MARYLAND DEPARTMENT OF THE ENVIRONMENT
Oil Control Program, Suite 620, 1800 Washington Blvd., Baltimore MD 21230-1719
410-537-3442 410-537-3092 (fax) 1-800-633-6101, ext. 3442

March 25, 2014

RE: RESPONSES TO QUESTIONS
Case No. 1987-2534-KE
Chester River Hospital Center
100 Brown Street, Chestertown
Kent County, Maryland
Facility I.D. No. 3168

Cross Section of Chester
 River Hospital Center
 Chestertown, Maryland

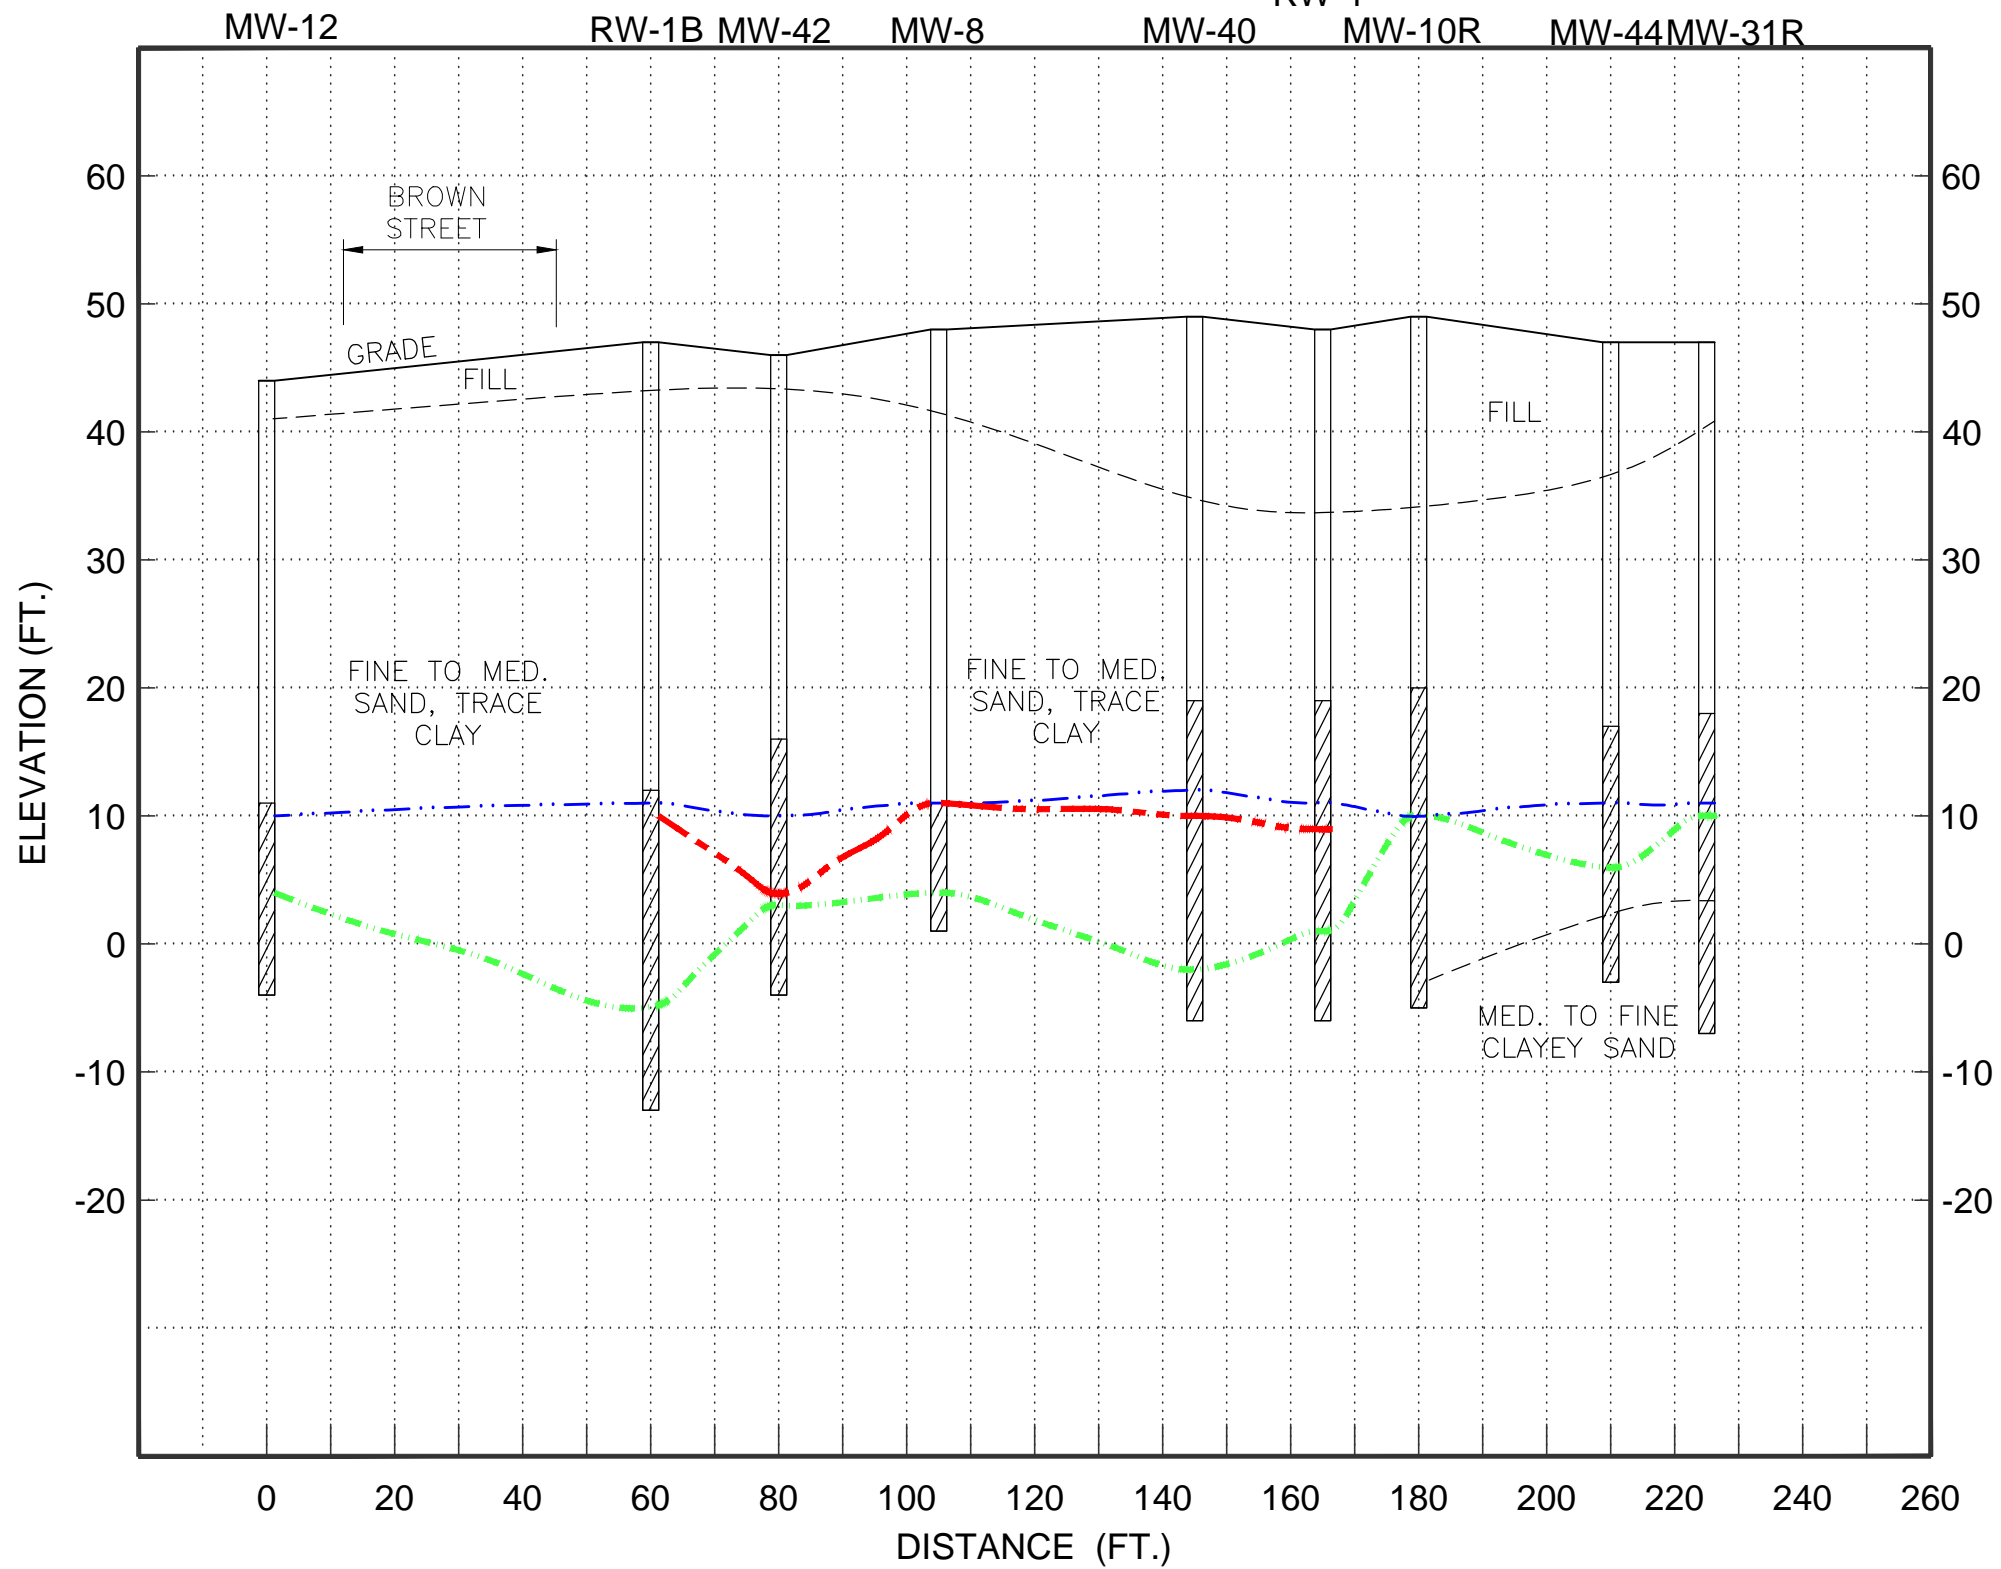
As demonstrated in the attached cross-sections, the subsurface geology is relatively uniform and the smear zone is adequately characterized. The existing well network adequately covers the site and the monitoring wells are constructed to depths that coincide with the upper portions of the municipal wells.
